Report to the Future Melbourne Committee**Agenda item 6.2****Ministerial Planning Referral: ID-2020-7, 21 - 35 Power Street, Southbank****20 April 2021****Presenter:** Larry Parsons, Practice Leader Land Use and Development**Purpose and background**

MINISTERIAL PLANNING REFERRAL DELEGATE REPORT

Application number:	ID-2020-7
DELWP reference:	Planning Scheme Amendment C398MELB
Applicant / Owner / Architect:	SJB Planning GL Investment Company Melbourne Pty. Ltd. Grimshaw Architects
Address:	21 - 35 Power Street, Southbank
Proposal:	Amendment to Melbourne Planning Scheme to apply Specific Controls Overlay (SCO) to the land and introduce a new Incorporated Document (ID)
Cost of works:	\$308,600,000
Date received by City of Melbourne:	26 November 2020
Responsible officer:	Connor Perrott, Principal Urban Planner

Figure 14A - Ground floor plan of proposed development (source: application plans prepared by Grimshaw Architects)

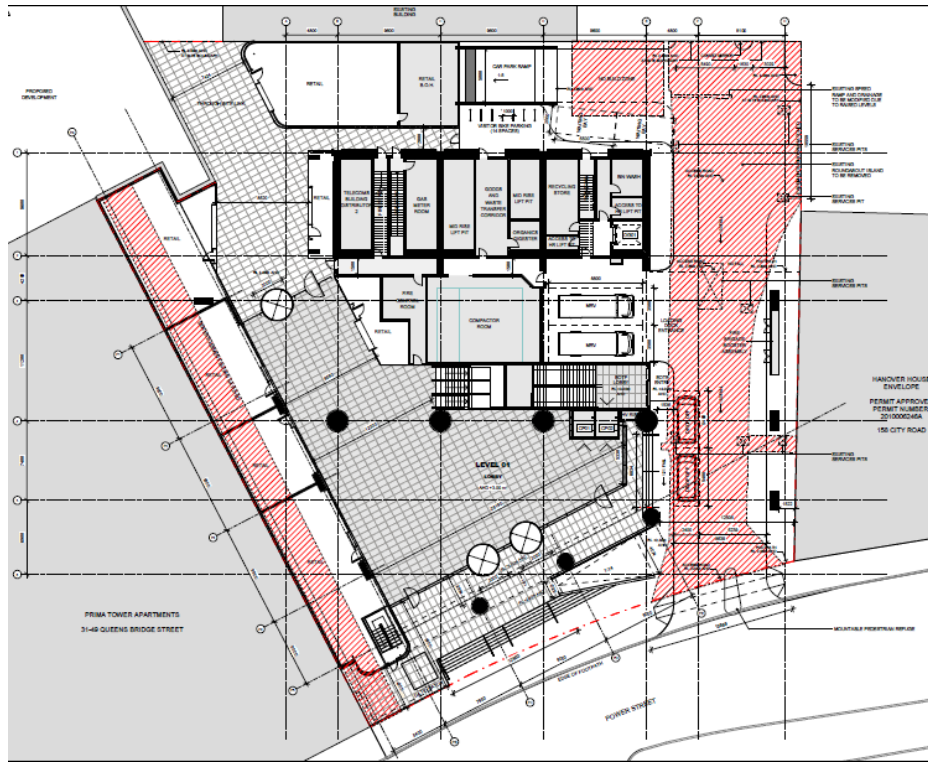
- Northern east-west connection -
 - A number of doorways / exit points open out onto this footpath. This footpath should be modified accordingly to limit potential conflicts.

- The ground plane has limited human scale, activation and street front connections. This, in turn, undermines the contribution the thru-block link makes to the public realm.
- Additional active uses should be provided along the Power Street frontage to increase pedestrian activity. This might include the provision of additional retail uses emphasised with robust materials / facade depths.
- All ramps and stairs leading to the Power Street entry should be further resolved. This includes the provision of landscaping to encourage the occupation of the space. Integrated seating across the forecourt would also assist in achieving this.
- The lobby could be further activated by way of the provision of flexible working areas, seating and landscaping.

- The footpaths alongside the driveway extending through the site increased to a minimum clear width of 1.8 metres. This width must be measured from the outside of adjacent columns / other obstructions. This might require the relocation or reduction in width of planters.

Figure 15: Approved and proposed tower floor plates
 (source: application documents prepared by SJB Planning)

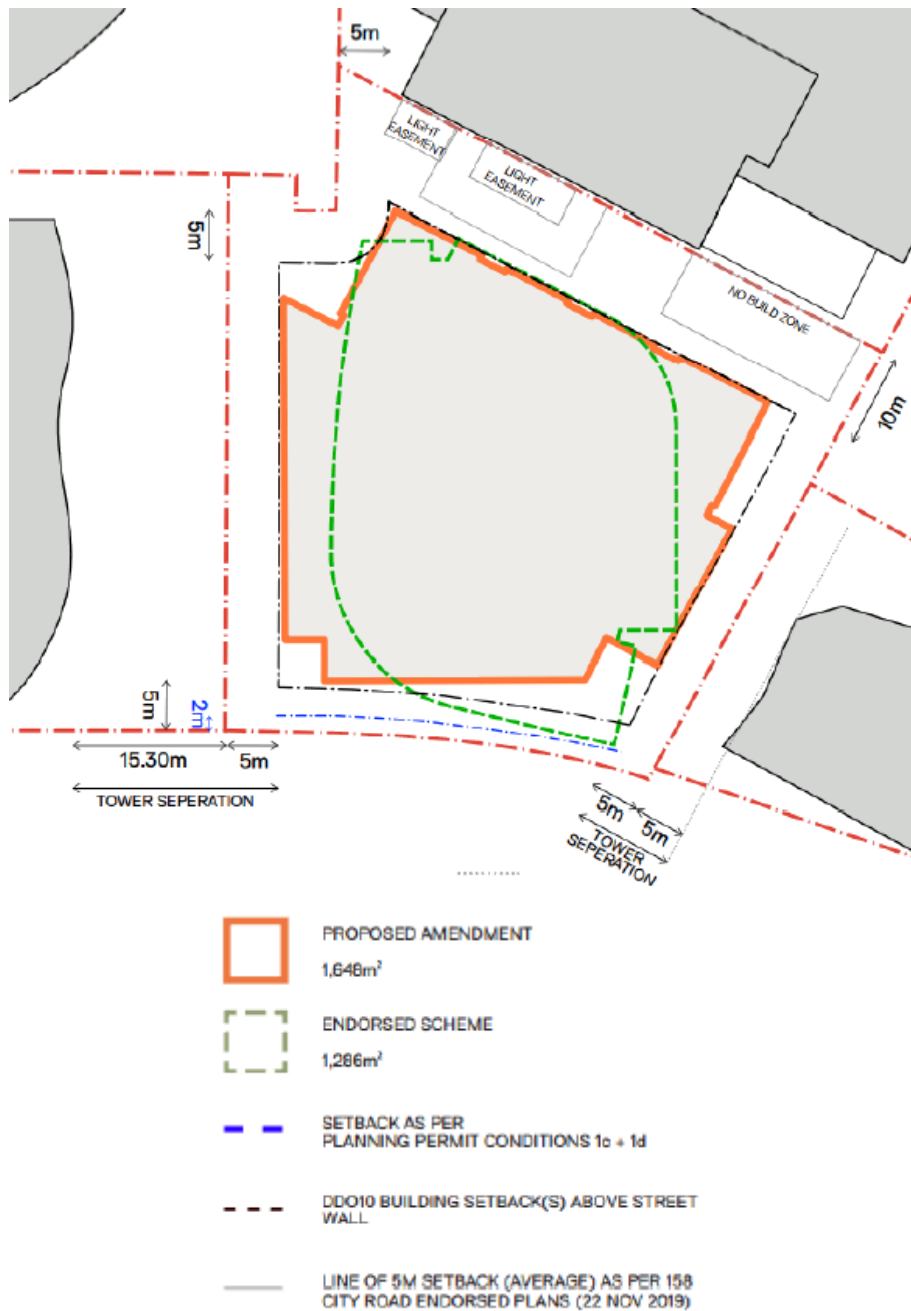
Given the height of the proposed building (215 metres), the tower floor plate does not comply with the mandatory provisions of Schedule 10 and is again therefore prohibited. As previously noted, setbacks of 12.9 metres are required from side and rear boundaries and setbacks of five metres (side) and 10 metres (rear) only would be provided. The floorplate can be adjusted under DDO10, but this requires a justified give and take trade-off which is not provided here.

- The tower floor plate would increase substantially from 1,266 square metres to 1,648 square metres given the noticeable reduction in side setbacks (refer Figure 15). This, in turn, would generate corresponding amenity impacts. This street block accommodates some of the tallest towers in the city and these require generous separation distances well in excess of the five and 10 metre setbacks currently proposed.

This surrounding context demands a responsive built form outcome. This should include a tower compliant with the key metrics of Schedule 10 as a minimum. Compliant side and rear setbacks (12.9 metres) would assist in ensuring an adequate sense of visual relief between adjacent towers and provide existing and future facing occupants with a sufficient degree of outlook.

Figure 16: Extent of shadows cast towards the Shrine of Remembrance by the approved and proposed buildings, 4pm 22 June (source: application documents prepared by SJB Planning)

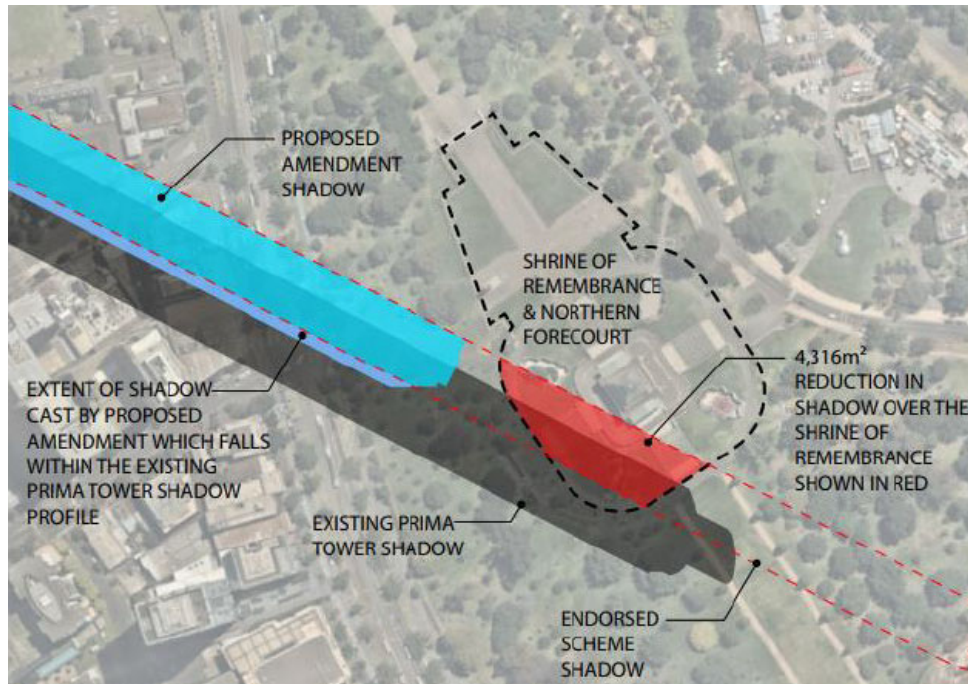
Figure 16 below shows the shadows which would be cast by the approved and proposed developments. As shown, the proposed development would not overshadow the Shrine at any time until at least 4pm, whilst the approved development would overshadow its south-west corner at 4pm on 22 June. Importantly, this is outside the times identified in the planning scheme. Given this, it is considered that the proposal should not be considered of state significance on the basis of reduced overshadowing, as claimed by the applicant.

The proposal produces limited overshadowing of the Shrine precinct late in the afternoon in winter. However, this is not within the control period in the planning scheme and is at a non-critical time, when other shadows also reach the area.

Though this has not been specifically confirmed by the applicant, using Figure 16 (from the application documents) as a guide, it is clear no such shadows would be cast. Given this, the approved development would not contravene the provisions of DDO10 nor those of Amendment C278, and as such reduced overshadowing should not render the proposed development of state significance.
